**Nuclear Innovation**  
North America LLC  
4000 Avenue F, Suite A  
Bay City, Texas 77414

July 27, 2011  
U7-C-NINA-NRC-110103

South Texas Project  
Units 3 and 4  
Docket Nos. 52-012 and 52-013  
Supplemental Response to Request for Additional Information

**RAI 03.07.02-13, Supplement 3****QUESTION:****(Follow-up Question to RAI 03.07.02-1)**

**Figure 3H.6-137: Formulations Used for Calculation of Factors of Safety Against Sliding and Overturning for Category I Site-Specific Structures**

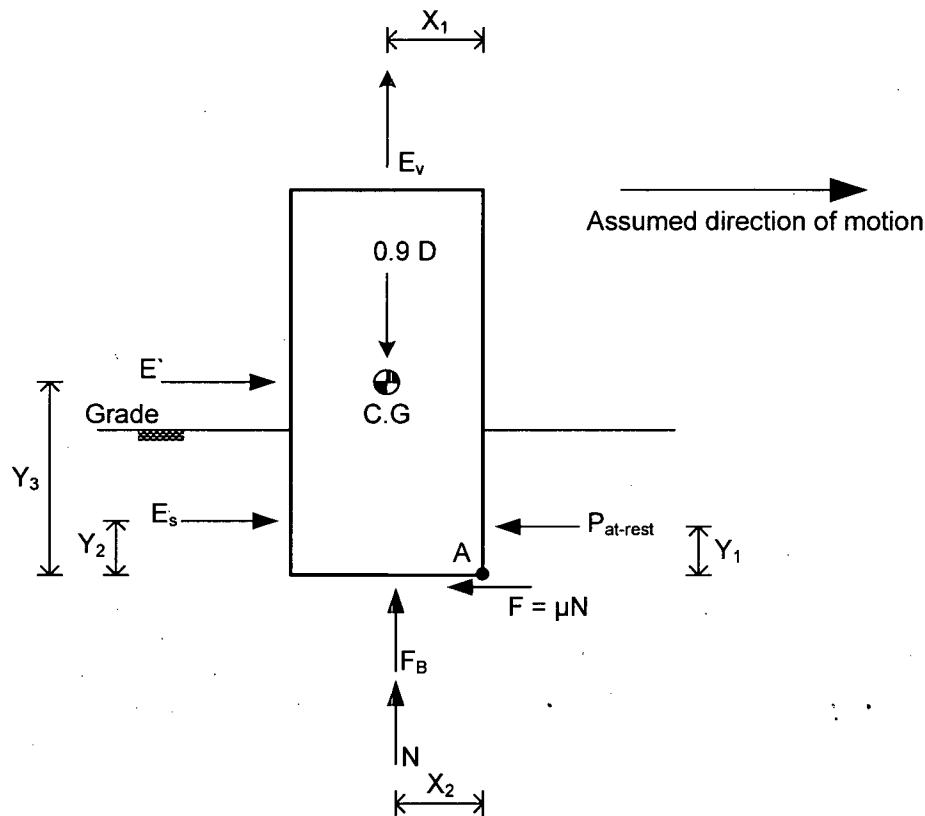
- c. *Clarify title for Figure 3H.6-137 to specify that it is applicable to Category I site-specific structures (Clarification Issue 17.5, Audit Action Item 3.8-33, Punch List Item 81)*

The title of Figure 3H.6-137 has been revised to specify that the figure is applicable to stability evaluation of Category I site-specific structures. See Enclosure 1 for revised Figure 3H.6-137.

**Figure 3.7-44 Radwaste Building East-West Input Motion for Stability Evaluations (7% Damping)**

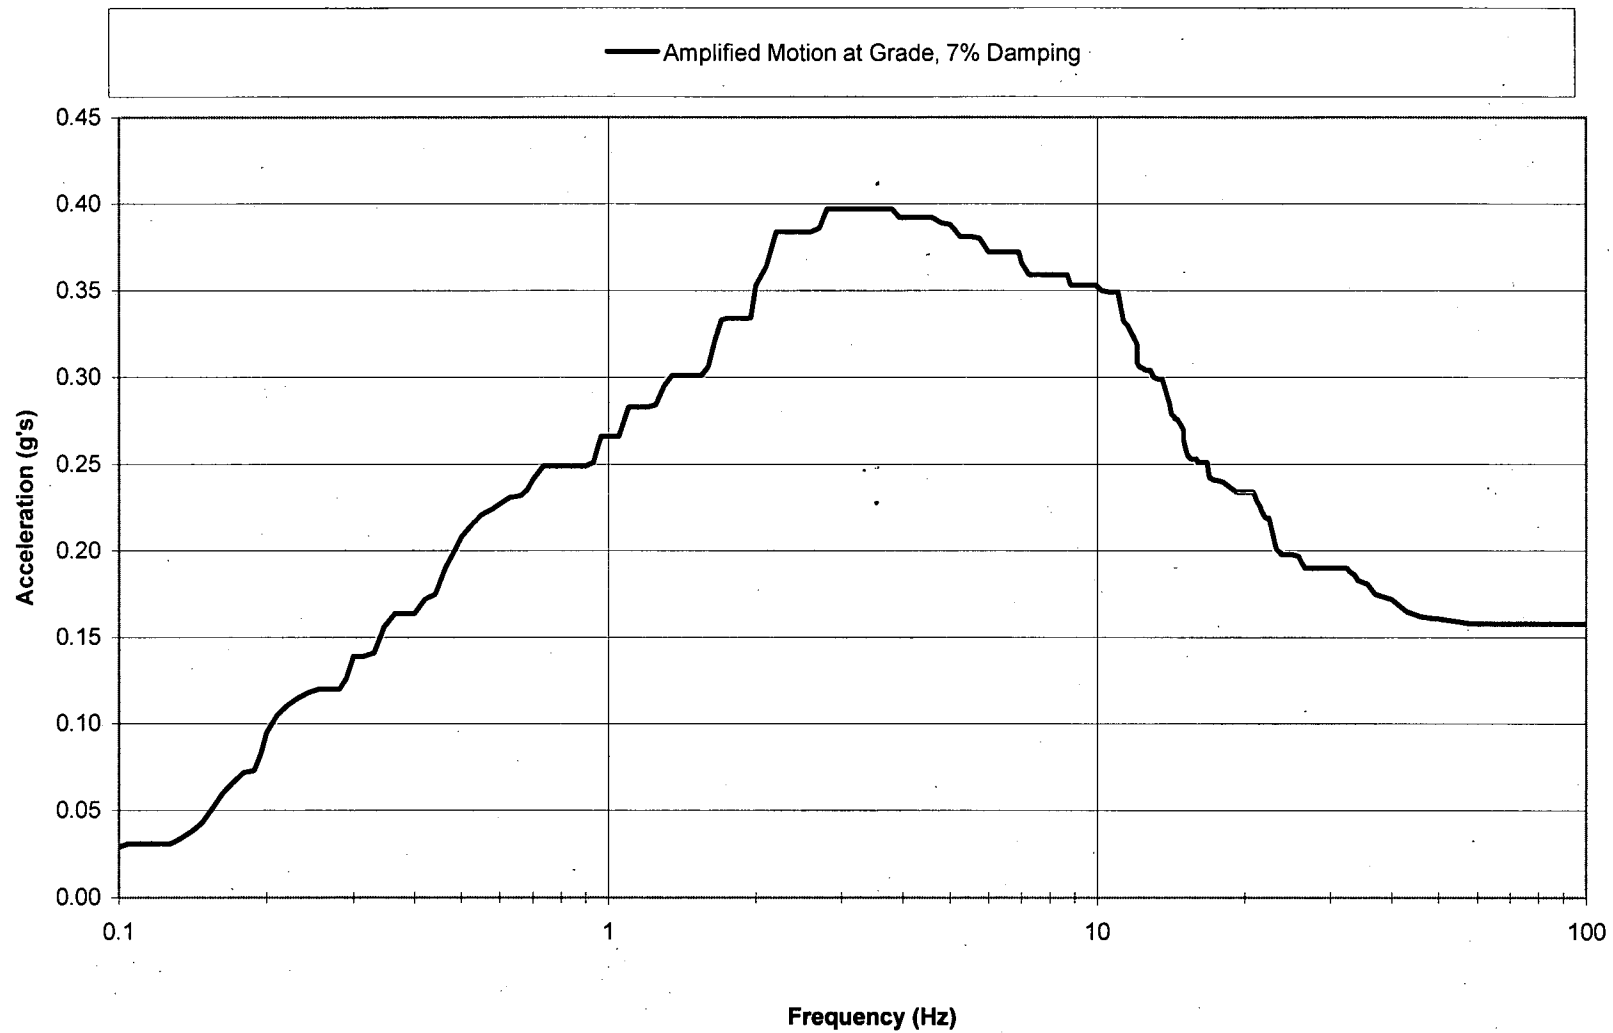
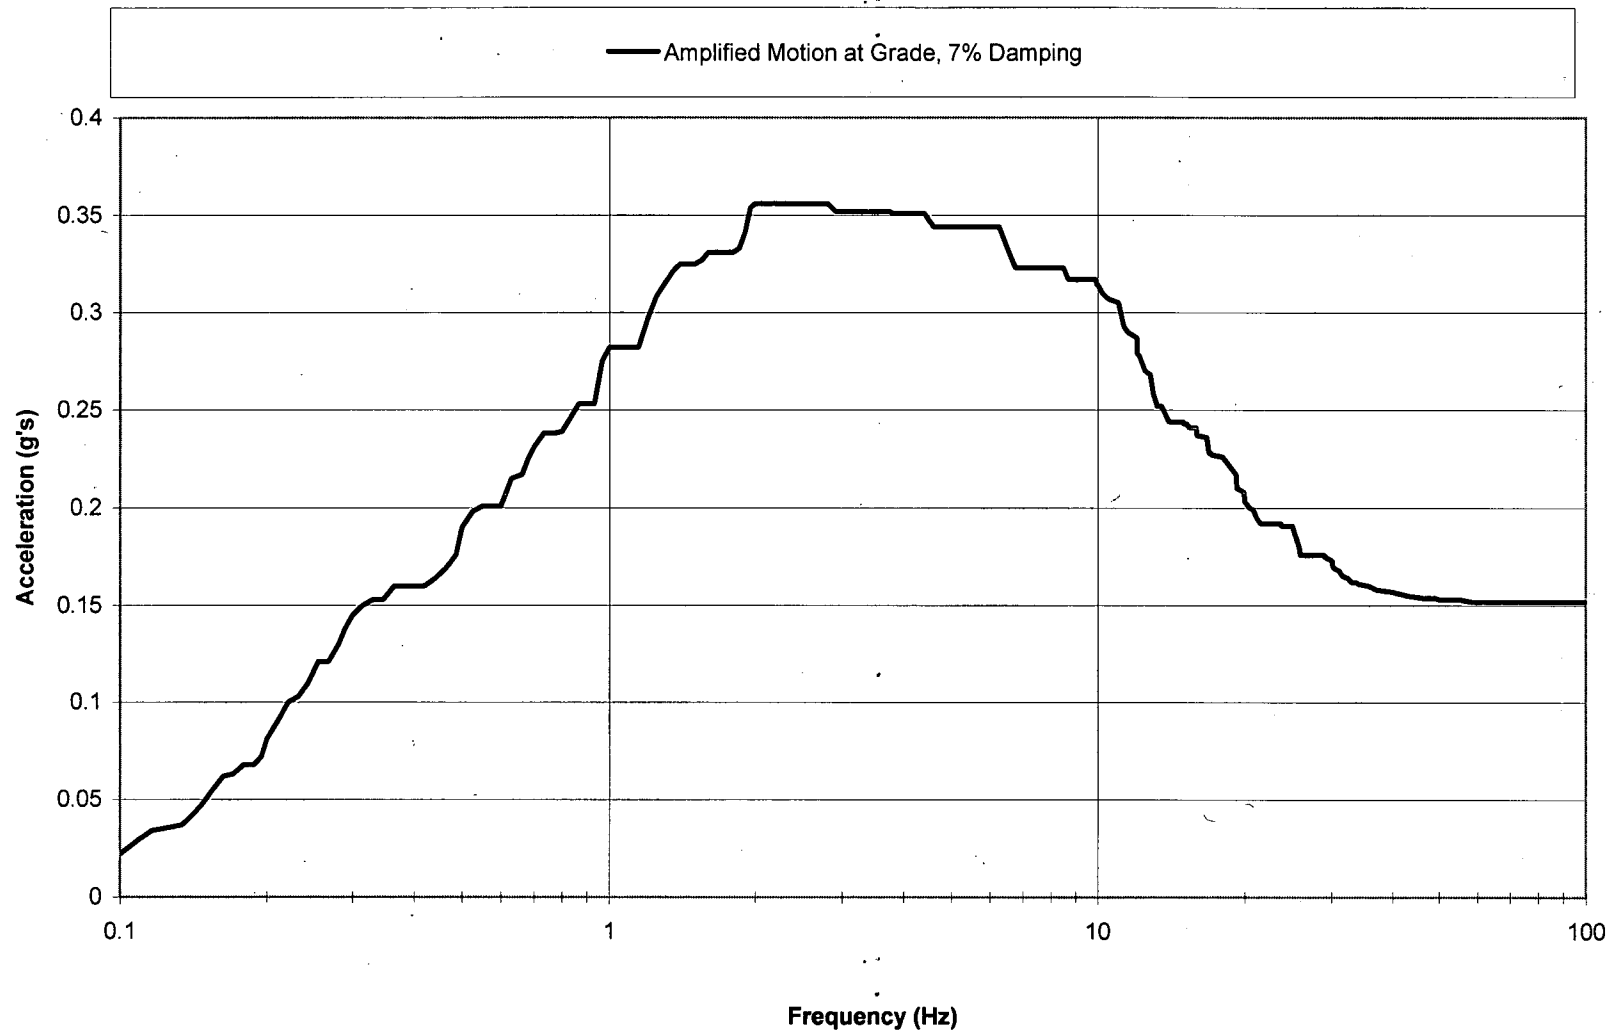
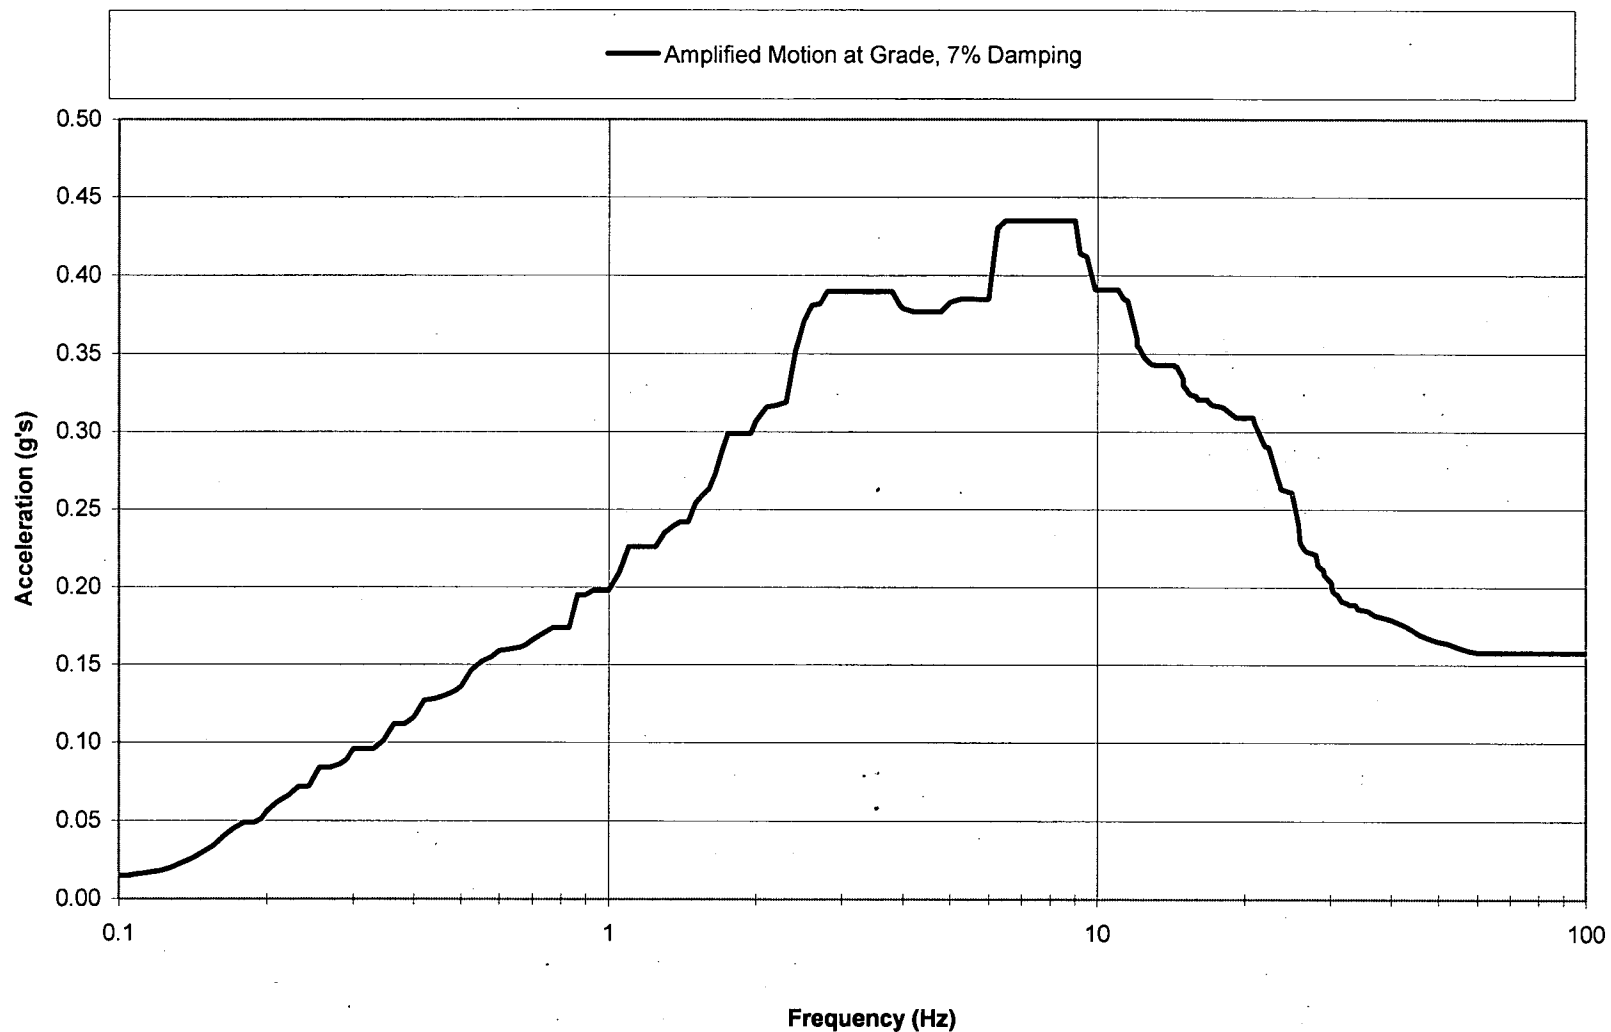
- b. *Revise RWB stability calculation considering amplified motion at ground surface and revise COLA as necessary (Audit Action Item 3.7-39, Punch List Item 73)*

The Radwaste Building (RWB) stability calculation has been revised using the amplified site-specific SSE motions at ground surface. These amplified motions are shown in new COLA Figures 3.7-44 through 3.7-46 in Enclosure 1. The revised sliding and overturning factors of safety are provided in revised Table 3H.6-14 in Enclosure 1.
